Technical Note

Project:	Finchwood Park Parcel 8	SMA Ref:	6860.TN09
Subject:	Response to WBC Refuse Comments	Revised:	—
Prepared by:	Tyler Andrews	Date:	15.08.2025
Checked by:	Kate Marshall	Date:	15.08.2025

SDL HIGHWAYS OFFICER COMMENTS

Application Number: 251457

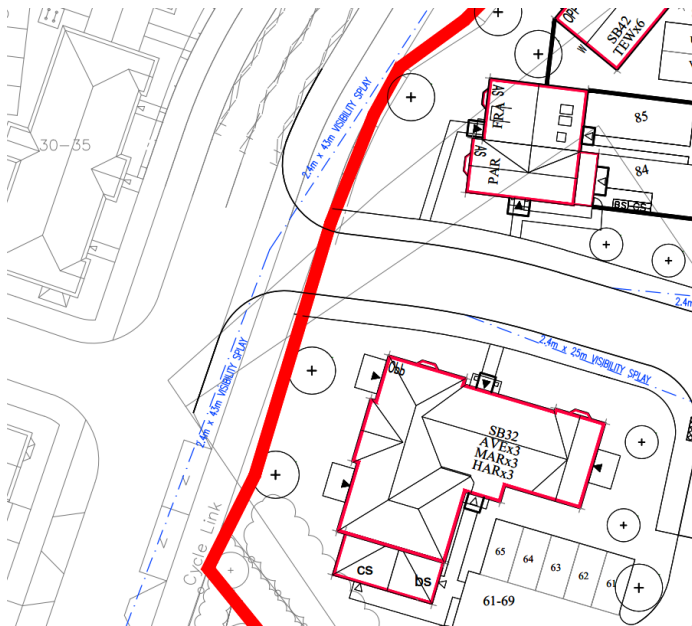
1. Drawing No. PLN-8-4005 (Rev. E) dated 28th February 2025 demonstrates visibility splays of 2.4m x 25m at internal site access junctions. This complies with the Manual for Streets visibility standard for the proposed 20mph speed limit. Corner radii of 4m and 6m are displayed for the access road north (hereafter 'A(N)') and south (hereafter 'A(S)'), respectively.

2. As A(N) provides access for 14 households, the minimum access road width is recommended to be 4.8m. As this road also provides access for refuse vehicle, the minimum width of the road should be no less than 5m.
3. The LHA require visibility to be measured using a 2.4m setback from the give-way line for the site access. The visibility splay has been measured from 1.6m at the primary site access junction, as shown on Stuart Michael Associates Drawing No. PLN-8-4005-Rev-E titled 'Visibility Splays Parcel 8 dated Feb 2022'. Any landscaping within these splays will need to be maintained to a maximum height of 0.6m and therefore it is crucial the splay is correctly demonstrated in accordance with MfS requirements.
4. The LHA require provision of a tabled crossing over the primary vehicle access junction to prioritise cyclists using the cycle link which passes the site.

Traffic Calming Features

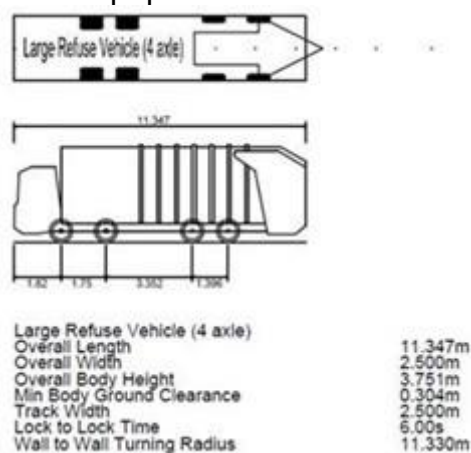
5. The LHA require the provision of physical speed reduction features along the proposed adopted carriageway. This section of straight road is 5.5m wide and c.100m long, which would result in vehicles exceeding the target speed of 20mph, set within the Wokingham Living Streets Guide (2019):
 - Features reducing vehicle speeds should be provided at 50-80m centres. This could take the form of traffic calming, such as speed cushions or built outs.
 - The design should naturally convey appropriate design speeds to drivers, with a target speed of 20mph specified in the Wokingham Living Streets Guidance(Link:<https://www.wokingham.gov.uk/sites/wokingham/files/2023-07/Highways%20design%20guide%20for%20developers.pdf>).

Distribution and Arrangement of Parking Spaces

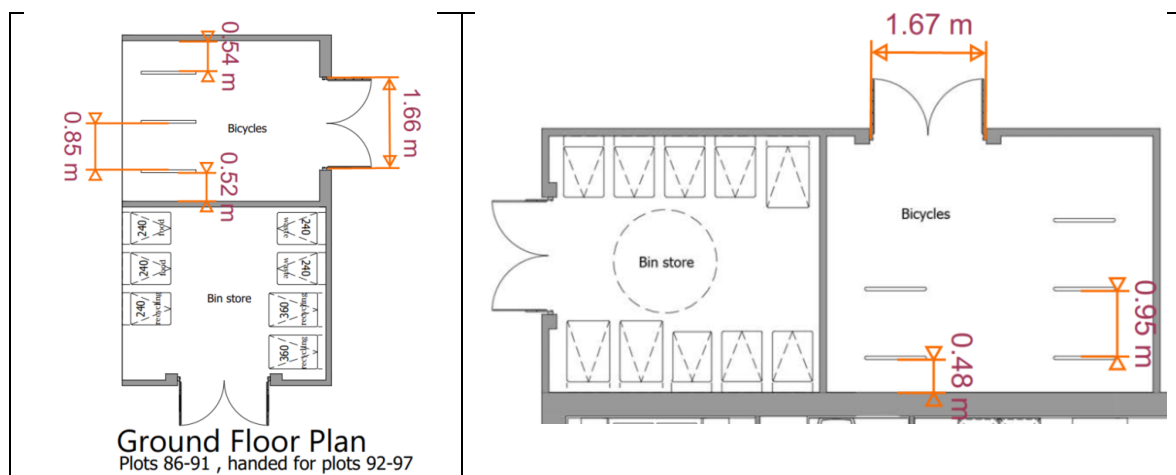
17. A minimum of 6m driveway clearance has been provided at the parking court of the flat blocks, for vehicle manoeuvring at forwards gear when leaving the highway. This is welcomed.

18. The proposed unallocated parking spaces are clustered around the flat blocks SB42, and similarly visitor parking spaces are clustered around the parking court opposite to Plots 70 and 71. The LHA recommend the visitor and unallocated spaces to be better distributed across the site.

19. The applicant shall explore the possibility for providing the parking spaces for Plot 75 on the same side of the dwelling.
20. To prevent additional parking that obstructs the turning head, it is recommended to reduce the driveway length for Plots 76-79, between the edge of carriageway and the garage, to no more than 13m.
